Stephen Timms, Principal Consents Planner
Environment Canterbury
PO Box 345
CHRISTCHURCH

17 October 2011

Thank-you for your letter of 29 September 2011 requesting further information in relation to the resource consent application to discharge stormwater in South-West Christchurch. This letter provides the Christchurch City Council's response to your letter, and as requested, includes a revised Monitoring Programme and draft consent conditions as part of this response. Christchurch City Council prepared this response in conjunction with Golder Associates (NZ) Ltd and Pattle Delamore Partners Ltd.

Figure 10-1: Example of relationship between average monthly spring-fed stream flow and groundwater level

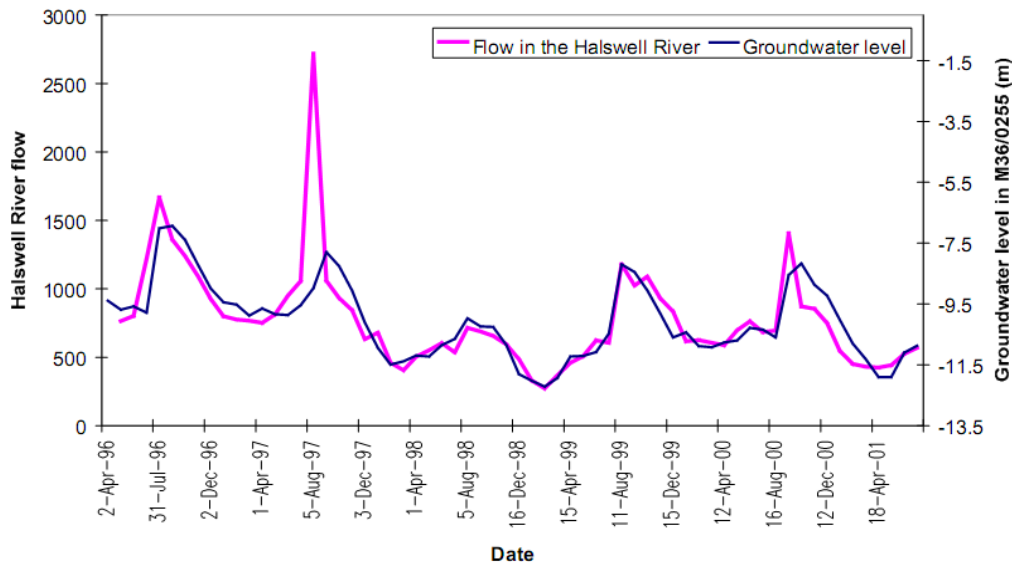
5. *The Halswell Drainage scheme is sensitive to increased groundwater levels and baseflows. Please provide information on what effect increases in groundwater levels would have on the downstream drains and Halswell River in the upper and middle reaches of the Halswell River catchment.*

Baseflow for the overall Halswell catchment is more related to the upwelling of water from the wider aquifer systems under the Canterbury plains as they come nearer to the coast. This wider scale effect is demonstrated by the relationship established between Halswell River baseflow and groundwater levels shown in the Figure below, which has been taken from the Canterbury Strategic Water Study (August 2002 report). This very good correlation is based on well M36/0255 which is located near Rolleston, approximately 10 – 15 km from the Halswell River, related to the river flow measured at Ryans Bridge.

This wider scale effect is not altered by development and will continue to provide base flows in the natural streams. No water is being put to ground in the Halswell catchment so the long term groundwater flows are not likely to be significantly increased as a result of the development. There will however be longer duration controlled flows in the Halswell after rainfall events as the water which would otherwise have been absorbed by the ground and evaporated, is channelled to the streams. The first 25 mm of each rainfall event is captured by the first flush basins which ensure these minor flows are managed.
